ATTACHMENT A

Marked-Up Pages

DRESDEN II DPR-19 Amendment No. 62, 82

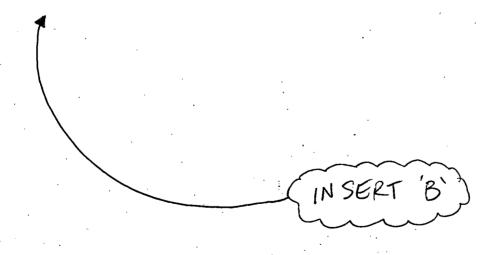
INSERT A

- D. Surveillance Requirements for inservice inspection and testing of ASME Code Class 1, 2, and 3 components shall be applicable as follows:
 - 1. Inservice Inspection of ASME Code Class 1, 2, and 3 components and inservice testing of ASME Code Class 1, 2, and 3 pumps and valves shall be performed in accordance with Section XI of the ASME Boiler and Pressure Vessel Code and applicable Addenda as required by 10 CFR Part 50, Section 50.55a(g) and 50.55a(f), respectively, except where specific written relief has been granted by the Commission pursuant to 10 CFR Part 50, Section 50.55a(g)(6)(i) or 50.55a(f)(6)(i), respectively.

- 2. Surveillance intervals specified in Section XI of the ASME Boiler and Pressure Vessel Code and applicable Addenda for the inservice inspection and testing activities required by the ASME Boiler and Pressure Vessel Code and applicable Addenda shall be applicable as follows in these Technical Specifications:

- 3. The provisions of Specification 1.0.CC.a are applicable to the above required frequencies for performing inservice inspection and testing activities.
- 4. Performance of the above inservice inspection and testing activities shall be in addition to other specified Surveillance Requirements.
- 5. Nothing in the ASME Boiler and Pressure Vessel Code shall be construed to supersede the requirements of any Technical Specification.
- 6. The Inservice Inspection Program for piping identified in NRC Generic Letter 88-01 shall be performed in accordance with the staff positions on schedule, methods, and personnel and sample expansion included in Generic Letter 88-01 or in accordance with alternate measures approved by the NRC staff.

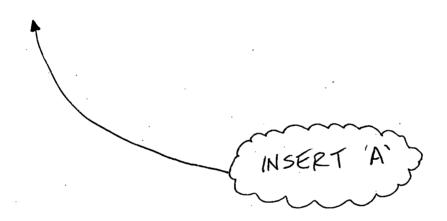
INSERT B

3.0.D Specification 3.0.D establishes the requirement that inservice inspection of ASME Code Class 1, 2, and 3 components and inservice testing of ASME Code Class 1, 2, and 3 pumps and valves shall be performed in accordance with a periodically updated version of Section XI of the ASME Boiler and Pressure Vessel Code and Addenda as required by 10 CFR 50.55a. These requirements apply except when relief has been provided in writing by the Commission.

This specification includes a clarification of the frequencies for performing the inservice inspection and testing activities required by Section XI of the ASME Boiler and Pressure Vessel Code and applicable Addenda. This clarification is provided to ensure consistency in surveillance intervals throughout the Technical Specifications and to remove any ambiguities relative to the frequencies for performing the required inservice inspection and testing activities.

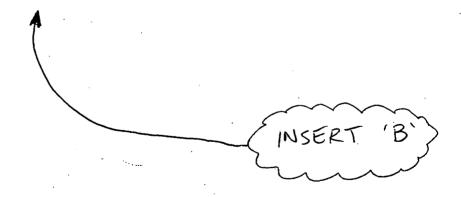
INSERT A

- D. Surveillance Requirements for inservice inspection and testing of ASME Code Class 1, 2, and 3 components shall be applicable as follows:
 - 1. Inservice Inspection of ASME Code Class 1, 2, and 3 components and inservice testing of ASME Code Class 1, 2, and 3 pumps and valves shall be performed in accordance with Section XI of the ASME Boiler and Pressure Vessel Code and applicable Addenda as required by 10 CFR Part 50, Section 50.55a(g) and 50.55a(f), respectively, except where specific written relief has been granted by the Commission pursuant to 10 CFR Part 50, Section 50.55a(g)(6)(i) or 50.55a(f)(6)(i), respectively.

- 2. Surveillance intervals specified in Section XI of the ASME Boiler and Pressure Vessel Code and applicable Addenda for the inservice inspection and testing activities required by the ASME Boiler and Pressure Vessel Code and applicable Addenda shall be applicable as follows in these Technical Specifications:

- 3. The provisions of Specification 1.0.CC.a are applicable to the above required frequencies for performing inservice inspection and testing activities.
- 4. Performance of the above inservice inspection and testing activities shall be in addition to other specified Surveillance Requirements.
- 5. Nothing in the ASME Boiler and Pressure Vessel Code shall be construed to supersede the requirements of any Technical Specification.
- 6. The Inservice Inspection Program for piping identified in NRC Generic Letter 88-01 shall be performed in accordance with the staff positions on schedule, methods, and personnel and sample expansion included in Generic Letter 88-01 or in accordance with alternate measures approved by the NRC staff.
